## HARPETH RIVER WATERSHED ASSOCIATION

Re: Additional Comments on the three draft NPDES sewage treatment permits on the Harpeth River in Williamson County: City of Franklin (TN0028827), Berry's Chapel Utility STP (TN0029718), Cartwright Creek (TN0027278)

Figure 4-16

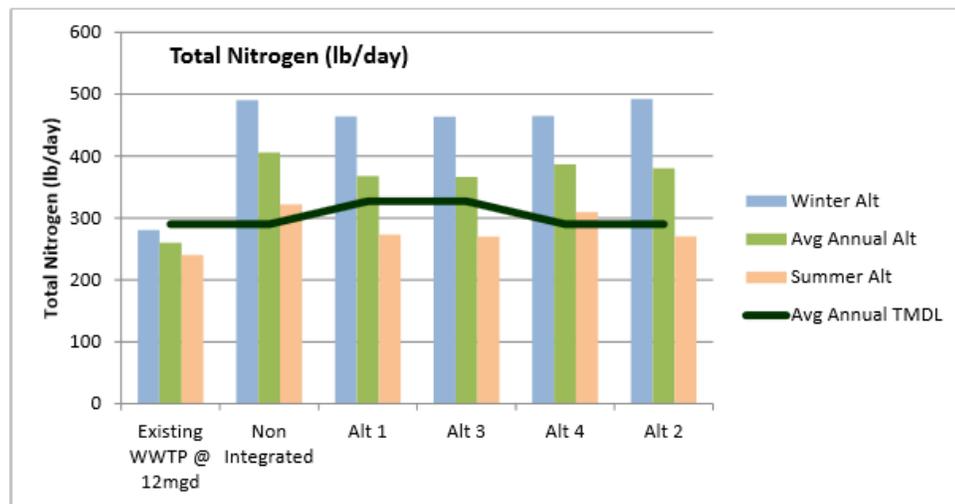
4. The modeling work done to screen the various options was not able to incorporate the entire load at 24 MGD of treated effluent without cutting the amount of Sediment Oxygen Demand in HALF. CDMSmith tried to use the SOD field data collected by EPA for the TMDL, but the D.O. charts dipped way below the minimum of 5 mg/l. Also the modeling did not line up the output of its DO data to the city's field, grab, data based on the time of day it the city's data was collected. This had the added effort of adjusting the model's output of DO data up along the graph since the grab data was not capturing the low values found in the early morning or late night. The effect of using HALF of the SOD data and "curve fitting" to the city's DO grab data was that the lines shown on the example DO chart in the Franklin draft permit is HIGH, moved up the scale about 2 -4 mg/l.

mostly HRWA and USGS. There is no doubt that the EPA's 3 SOD field values are not robust, still the values are in line with what to expect in the Harpeth. In the summer it is shallow and warm and moves slowly. This allows sediment to have a reasonable influence in reducing DO in the water. Modeling is unfortunately rife with lack of data and sensitivities to a key assumption. The important point is that the outputs from the model did not find any of the IWRP options that would keep the DO at or above standards. Essentially the charts really should be about 2 mg/l lower. This means that 24 MGD of treated effluent in the river is NOT going to be assimilated by the river in the summer. Also the options that would work have not been analyzed yet and probably can't be until river studies are done and a new TMDL prepared.
